Planning Application Ref: AW/286/21/T

Location: 55 Colts Bay, Aldwick, PO21 4EH

Description of works: 1no. oak tree - Crown reduction to leave height 15m and spread approx. 7-8m

Figure 2 Positions of final cuts

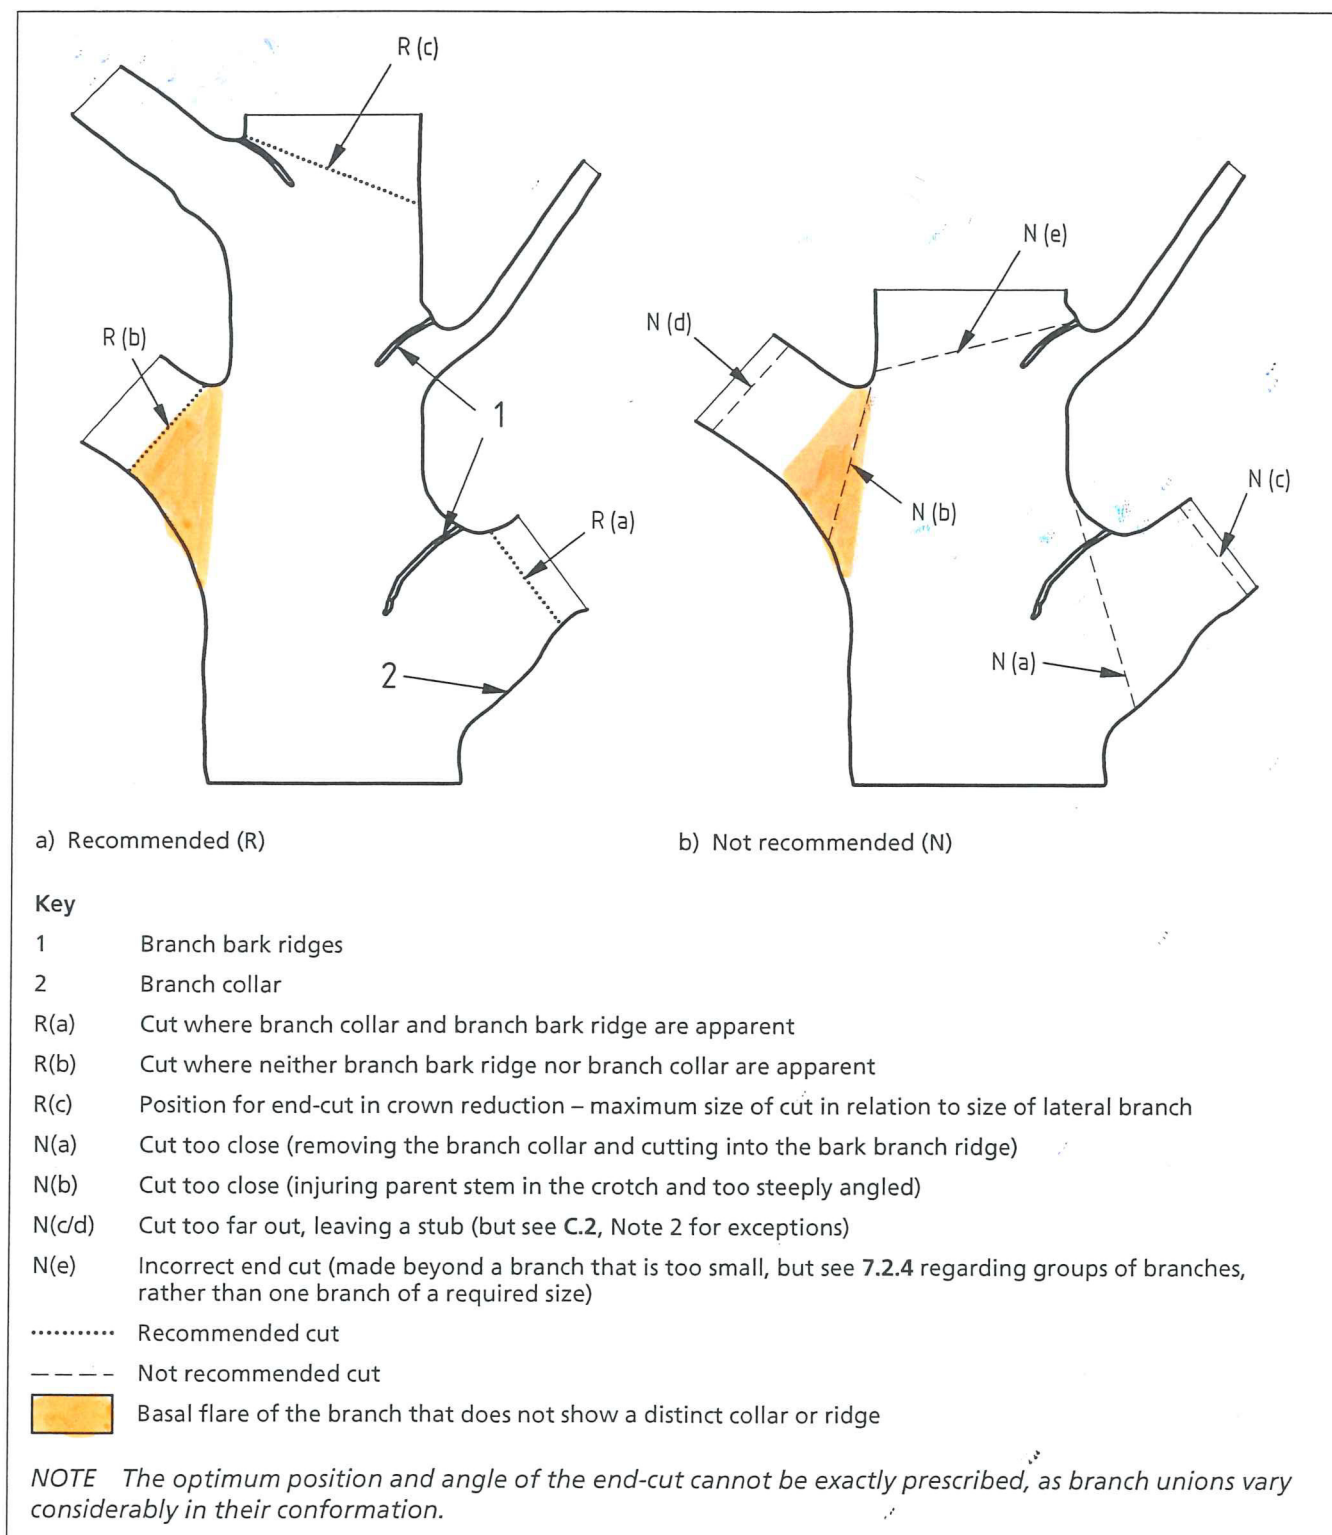
Part a) Where whole branches are to be removed and final cuts made close to the trunk or branch union they are to be made as shown in Figure 2 of BS3998:2010
